BOARD OF PUBLIC WORKS OF THE COUNTY OF KENT

April 27, 1983

RE: Response to Your Letter Dated March 30, 1983

FIGURE ONE

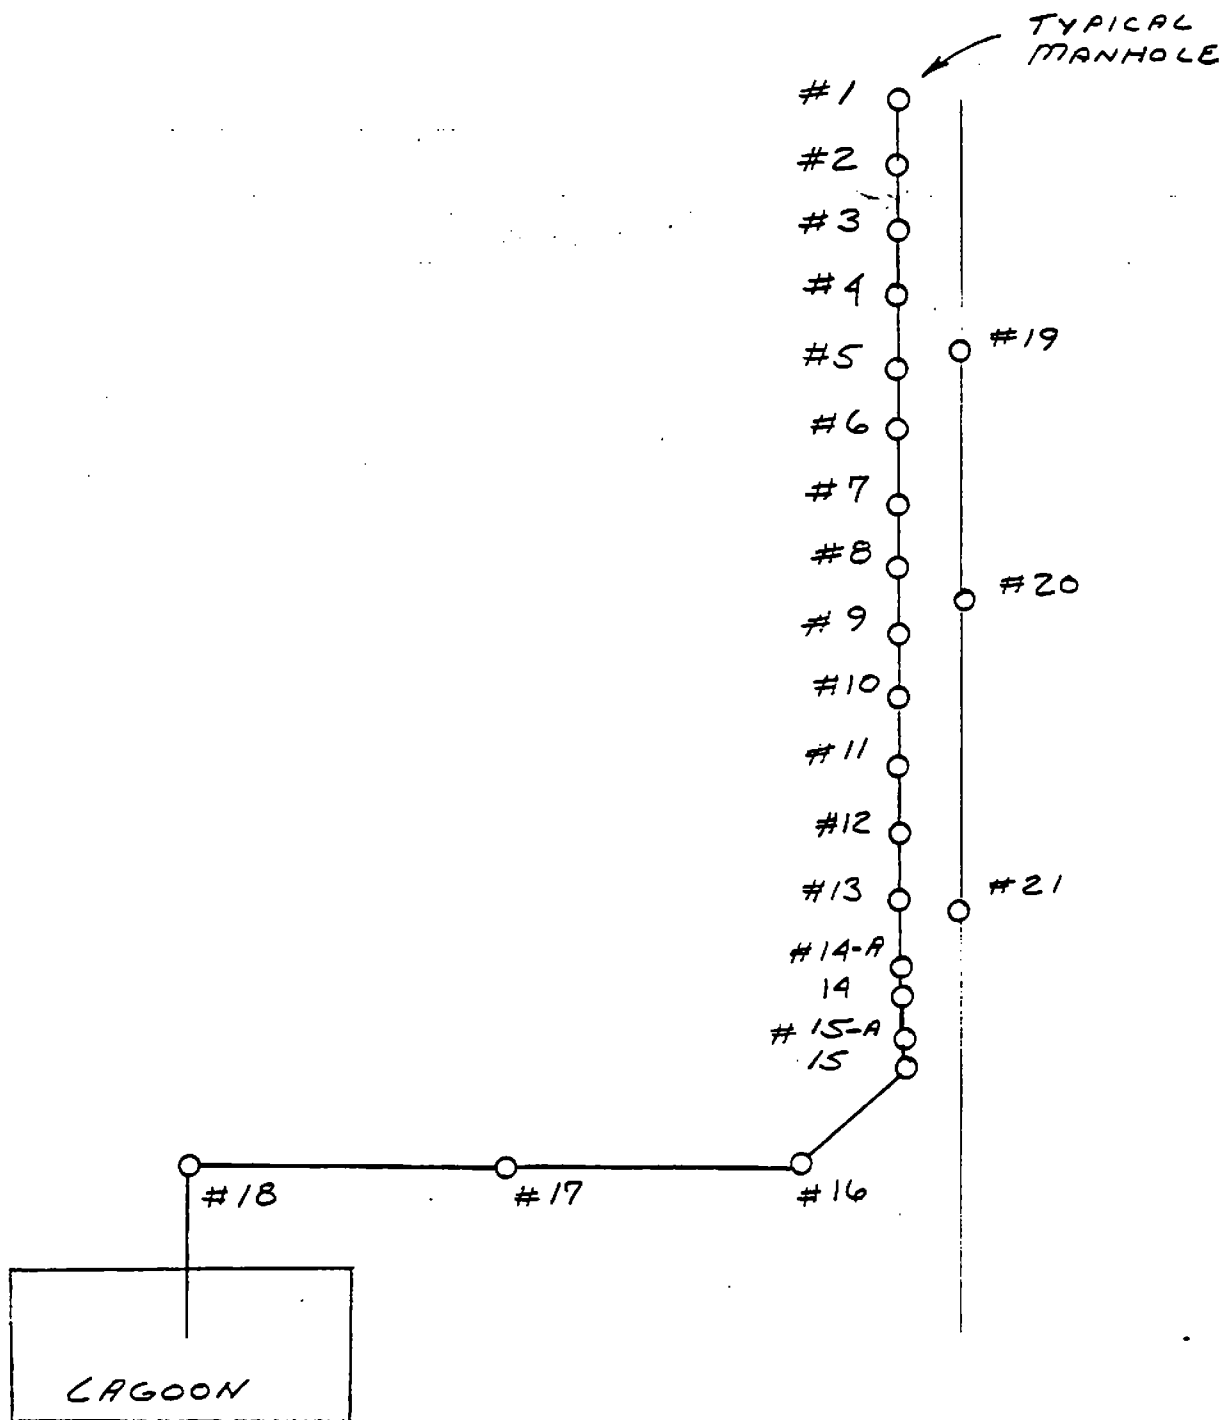
Since our last meeting, the D.P.W. staff disassembled some of the leachate collection system and did an inspection of all manholes. Our findings indicated that there is a constraint in the 8" gravity line between manholes number 2 and 3 (see attached sketch). There is approximately 12 feet of standing liquid in manholes number 1 and 2. All other manholes appear to be functioning normally. I have already contracted the services of a sewer cleaning contractor to remove the constraint and clean and perform television inspection of 1,500 feet of the 8" gravity sewer. This represents all the sewer that is directly underneath the active landfill area. The contractor is expected to complete the work within 60 days. Approval to do the work was given at the April 27, 1983, meeting of the Board of Public Works.
